# UNITED STATES PATENT AND TRADEMARK OFFICE

10/584,994

<b>Office Action Summary</b>	<b>Application No.</b> 10/584,994	<b>Applicant(s)</b> BAIRO, MASA AKI	
	<b>Examiner</b> W. Wendy Kuo	<b>Art Unit</b> 2826

### DETAILED ACTION

FIG. 10

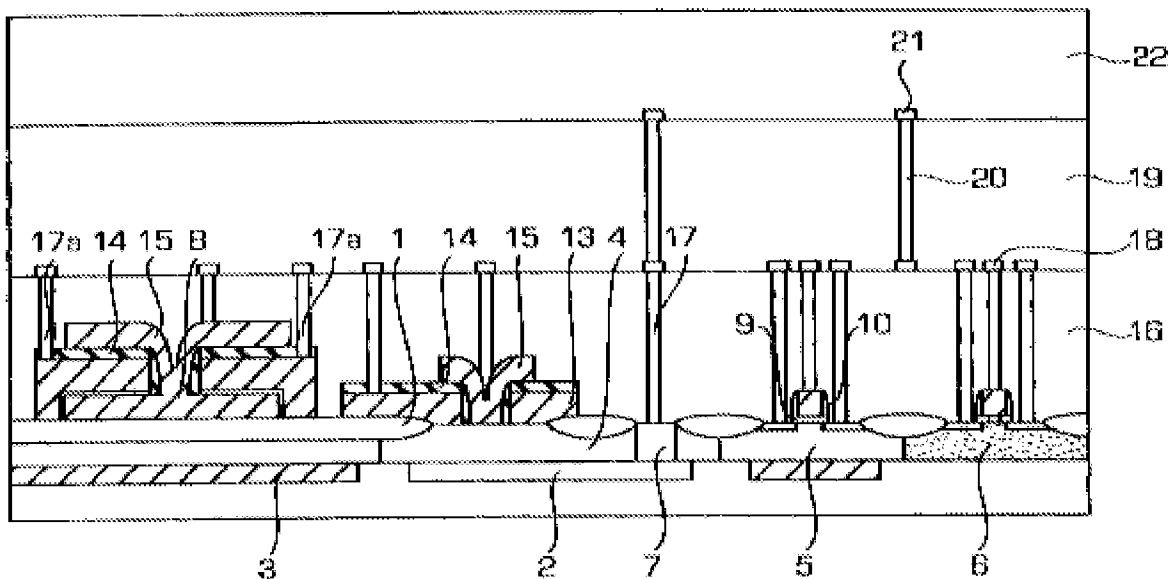
5. With respect to claim 9, Fujii (e.g. Figure 10) teaches a method for manufacturing a bipolar transistor, the method comprising the steps of:

- Forming a base layer 13 on an insulator 1, said base layer being in contact with a portion of a semiconductor substrate (2, 4; 30 Figure 3);
- Forming an insulating film 16 on said base layer 13;
- Forming base and emitter electrode lead openings within said insulating film 16 (column 8, lines 27-30);
- Depositing a conducting film (polysilicon) into said base electrode lead opening and into said emitter electrode lead opening, said conducting film within said base electrode lead opening being a base electrode lead portion and said conducting film within said emitter electrode lead opening being an emitter electrode lead portion (column 8, lines 27-30)

Fujii fails to teach that the base electrode lead opening is formed simultaneous with the emitter electrode lead opening. Fujii further fails to teach a step of polishing the conducting film to separate the base electrode lead portion from the emitter electrode lead portion. Hozumi teaches that the base electrode lead opening is formed simultaneous with the emitter electrode lead opening (column 6, lines 57-61) in order to realize the simultaneous production of a transistor and other elements with a simplified process of manufacture (column 7, lines 67-68; column 8, lines 1-10).

7. With respect to claim 10, Fujii (e.g. Figure 10) teaches that said insulator 1 is on said semiconductor substrate (2, 4; 30 Figure 3) with an opening within said insulator exposing said portion of the semiconductor substrate.

13. With respect to claim 15, Fujii (e.g. Figure 10) teaches a step of depositing an interlayer insulator 19 onto said silicide and said insulating film.
